AGENDA FOR REGULAR MEETING VILLAGE OF TINLEY PARK PLAN COMMISSION

SOUTHWEST CHICAGO CHRISTIAN SCHOOL – 17171 84TH AVENUE WORKSHOP: SITE PLAN APPROVAL, VARIATIONS

PLAN COMMISSION STAFF REPORT-Workshop

Site Plan Approval,
Variations

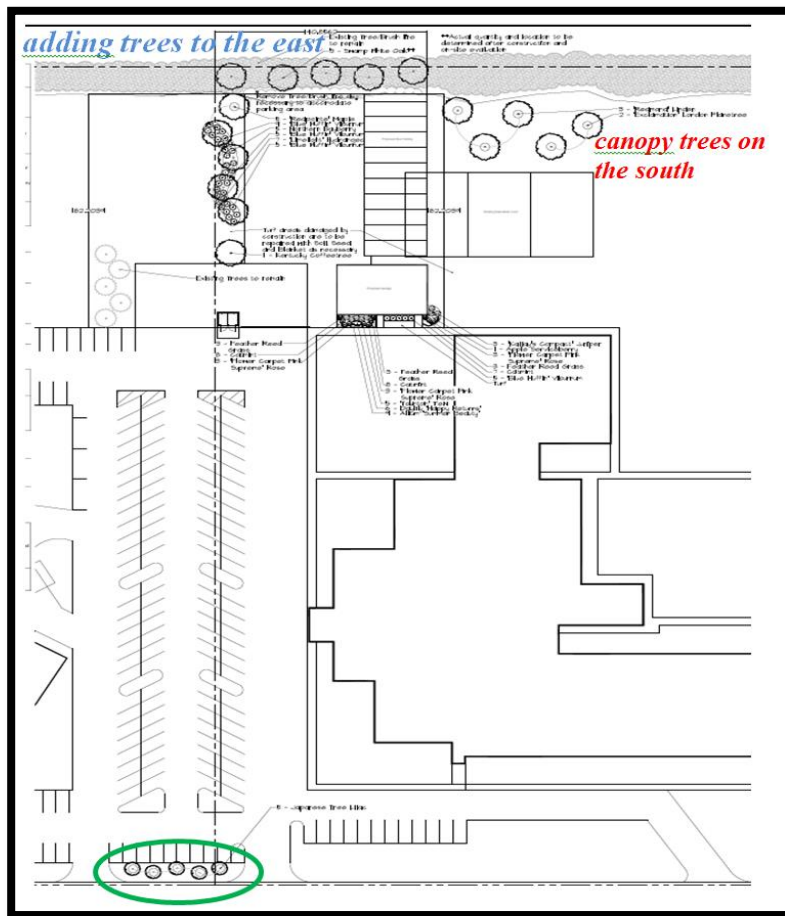
Open Item #1: Cargo containers are not allowed on a permanent basis; staff recommends any approval of the Site Plan include the removal of the cargo container.

CHICAGO SOUTHWEST CHRISTIAN SCHOOL
TINLEY PARK, IL
SITE UTILITY PLAN

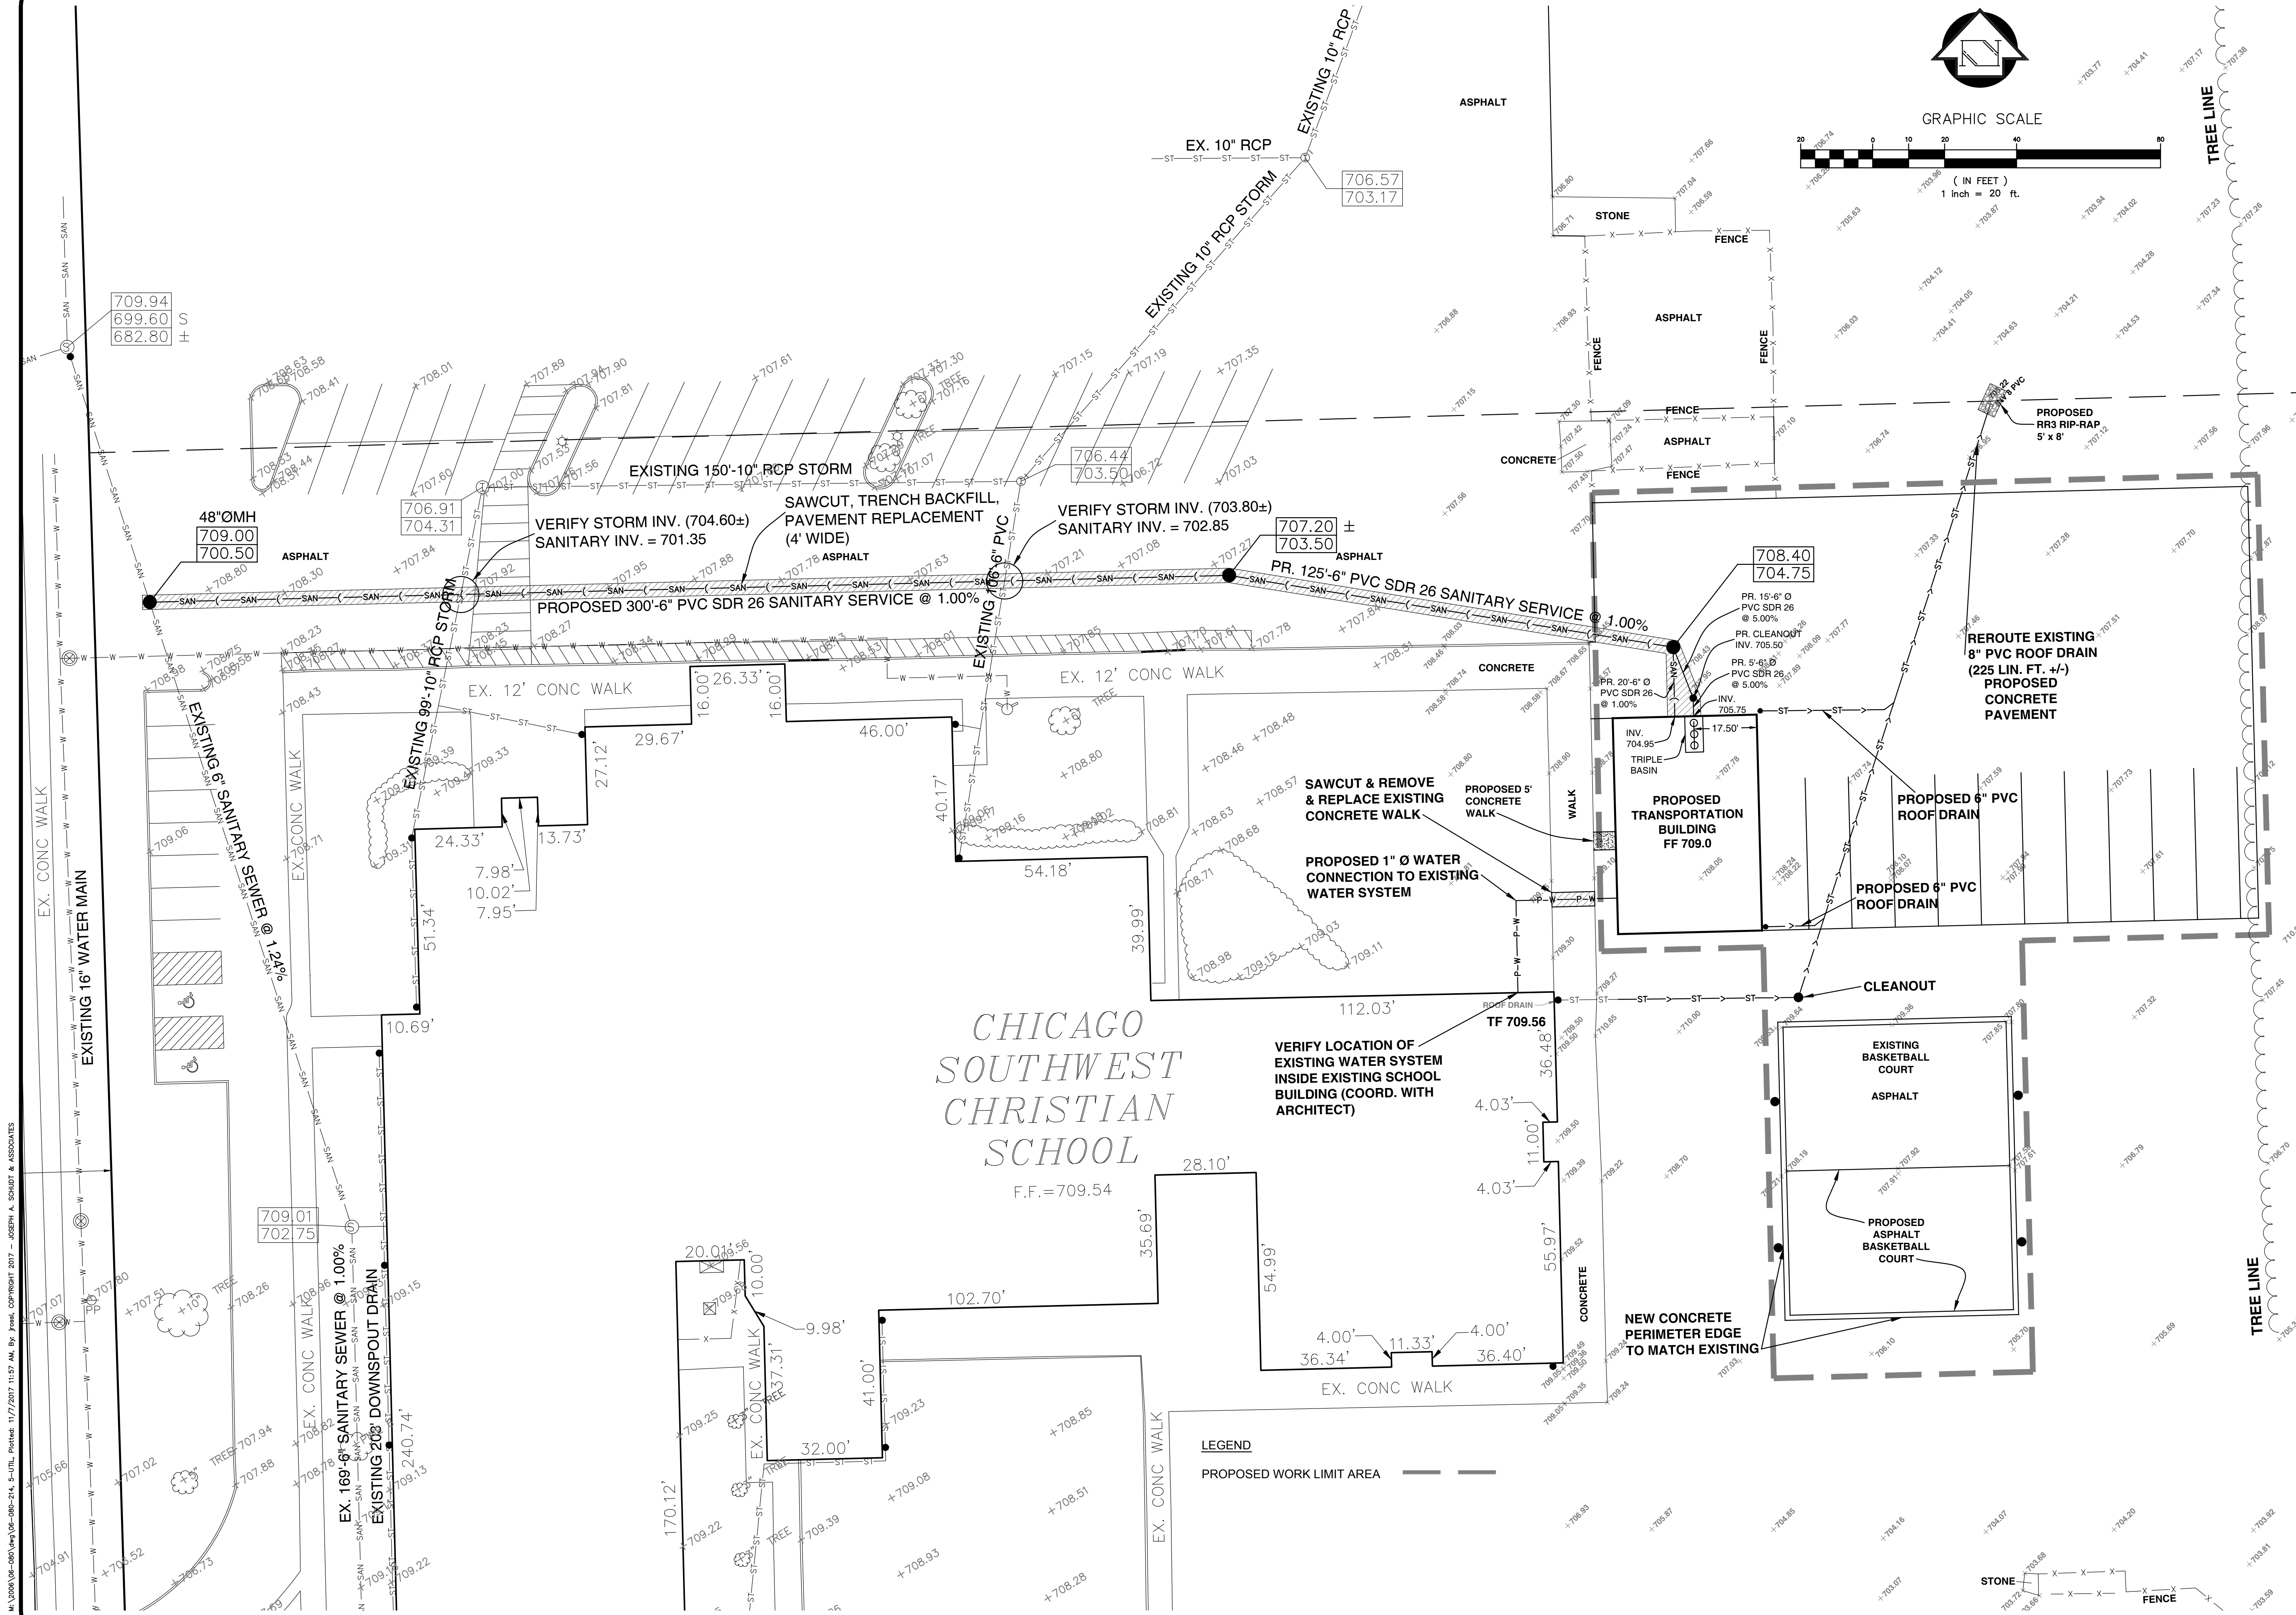
3. An MWRD permit will be required for the sanitary connection.
4. Please provide additional details on the sanitary sewer connection point including all inverts and method of connection for the existing pipes into the new manhole.

5. Please clarify the water main service material.
6. Is the concrete cross section for the parking lot pavement adequate?
7. The Illinois Department of Public Health is requiring that domestic and fire services be split inside the building. A fire service is considered a stagnant water line and violates the Illinois plumbing Code. Please clarify that the water service connection for this building shall be from existing potable water connection in the school.

CHICAGO SOUTHWEST CHRISTIAN SCHOOL
TINLEY PARK, IL
SITE DRAINAGE EXHIBIT

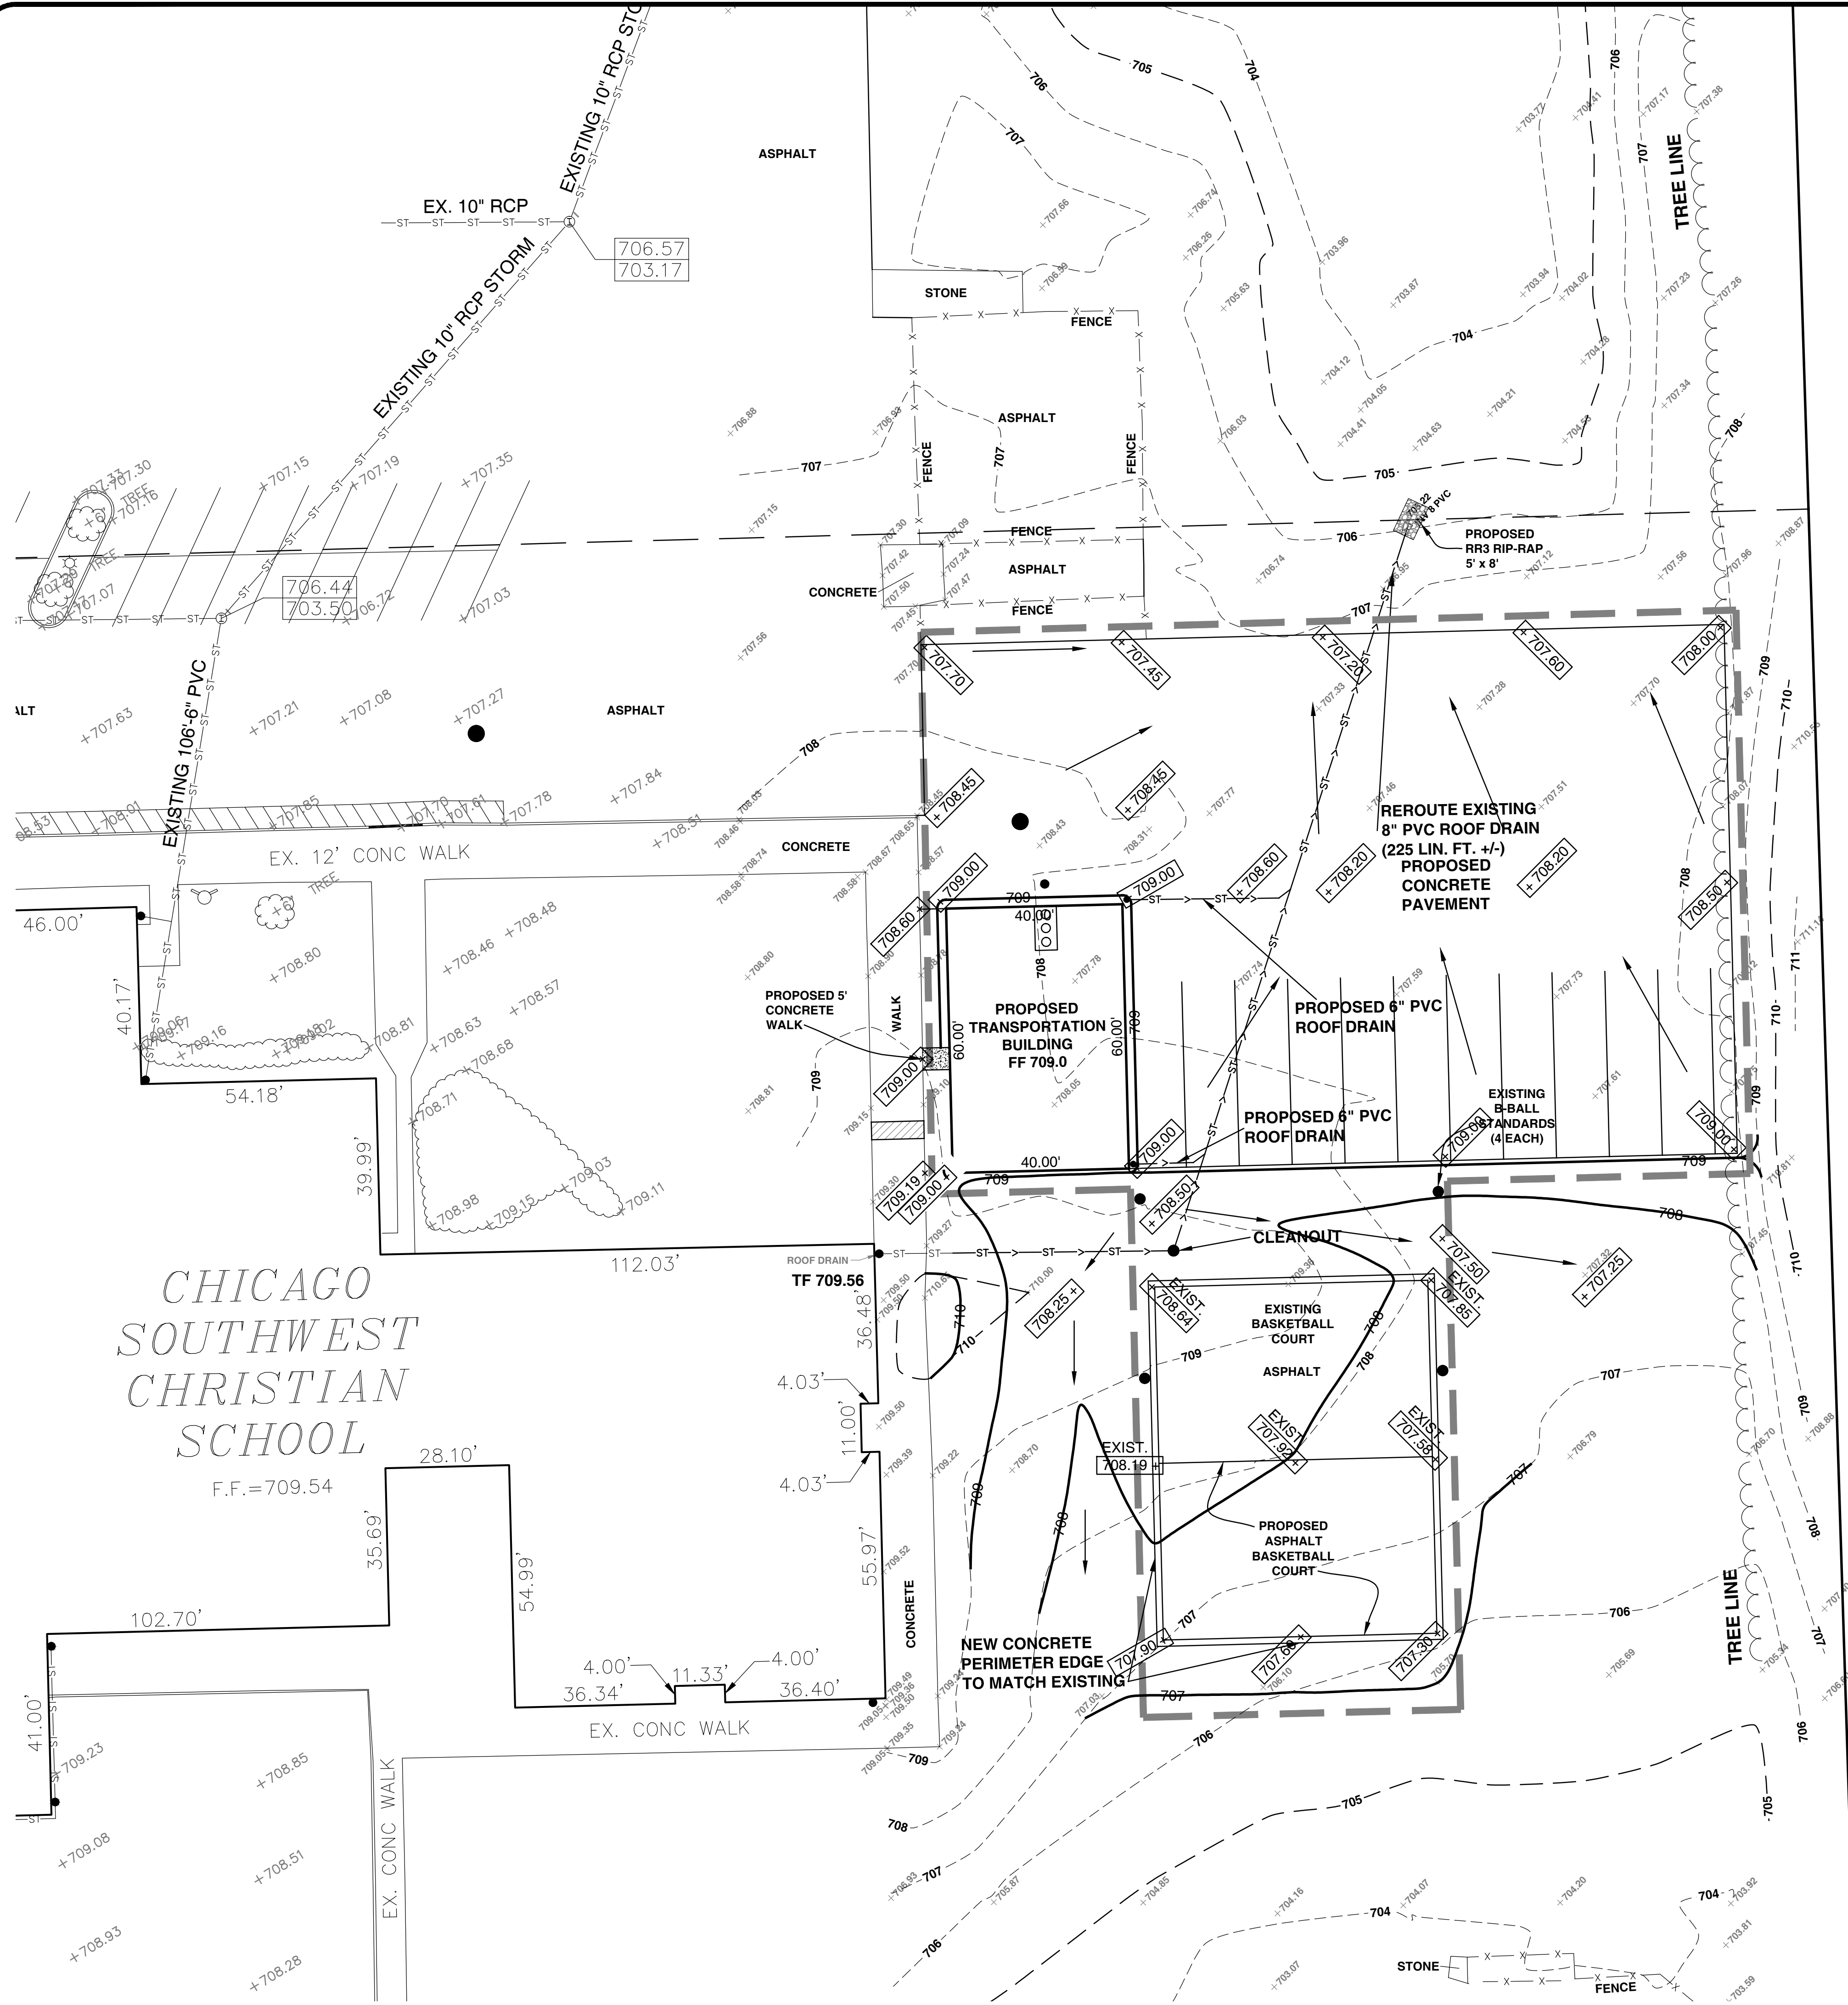
1. The storm water management requirements for this parcel are not clear. The drainage exhibit indicates the contiguous ownership acreage is far less than what is assumed. This will drive the applicability of the MWRD WMO. Please coordinate with the MWRD regarding the storm water management requirements for this site and provide the required modifications or obtain a permit determination letter and provide to us for our files.
